# **Comments on JBG's July 30 "Wiehle Character Overview"**

Bill Penniman

# WIEHLE AVENUE AREA: PLANNED FLOOR AREA RATIO

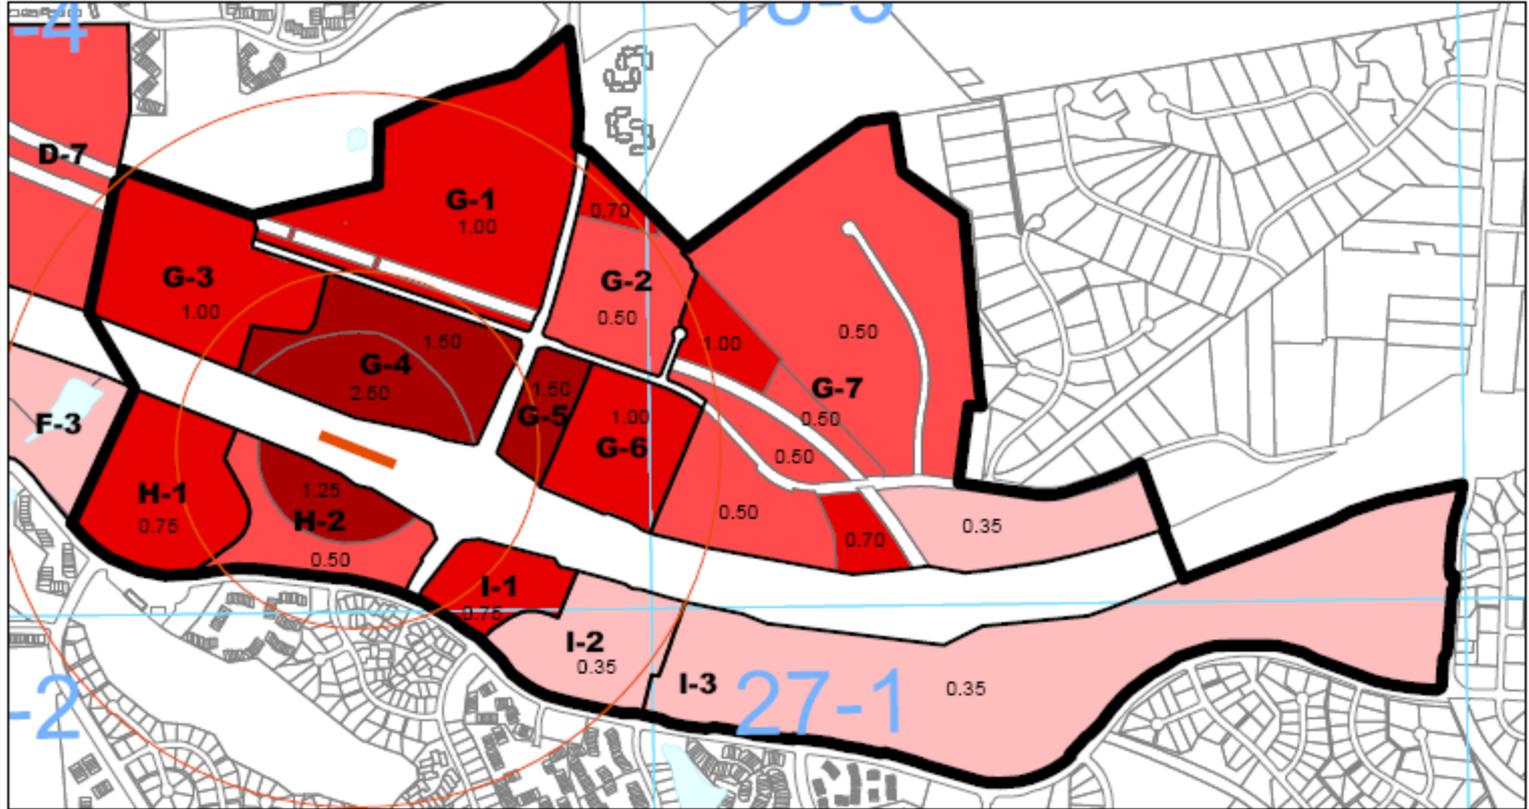
- **JBG overview proposes new “by right” FARs (1.0-2.5) -- up to 5 times current “by right” FARs**
  - Current “by right” FARs are ~0.35-0.5
  - Can go higher subject to evolving Comprehensive Plan guidelines and acceptable proffers
  - “By right” means generic standards, losing negotiation
- **TF should not change “by right” FARs even if CP changes are recommended**

- Raising FARs up to 5.0**
  - 2-10 times current CP levels**
  - Comstock (2.5 with multiple tall buildings)**
  - TC Urban Core (2.0)**
  - Above anything proposed to subcommittee by Wiehle area developers**
- Increasing densities up to 1.5 miles from station**
- Shifting focus from transit station to Wiehle Ave**

- Transit-oriented, non-motorized development is goal – if people won't walk, why bother?**
- Core –  $\frac{1}{4}$  mile (highest density  $\frac{1}{8}$  mile)**
- Limit  $\sim \frac{1}{2}$  mile**
- No CP change justified outside  $\frac{1}{2}$  mile radius, except possibly**
  - revamping Plaza America to serve larger market**
  - at fuzzy edges (e.g., Michael Farraday area)**
  - if special conditions are met (e.g., Fannie Mae with shuttle bus and large publicly accessible open space)**
